David Weinstein
51 Freese Road
Ithaca, NY 14850

March 30, 2022

Re: Comments on the Dryden 2045 Draft Comprehensive Plan

Page 52-

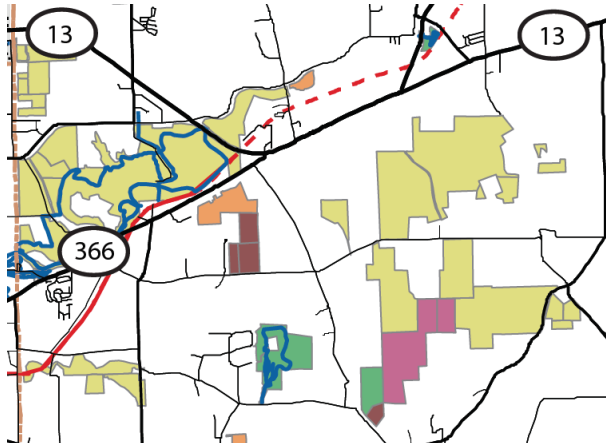
It is not clear why some of the areas on the west side of the town shown in the following excerpt from the map on page 53 were not listed as Natural Features Focus Areas with Connectivity Potential:

Although these areas, such as Monkey Run (left), Mt Pleasant (upper center), and Ellis Hollow Swamp (lower center) are smaller, they still connect substantial amounts of natural lands with migration potential for plant and animal populations. In the case of Monkey Run, it is connected to a streamside corridor that runs all the way to Cornell in the Town of Ithaca.
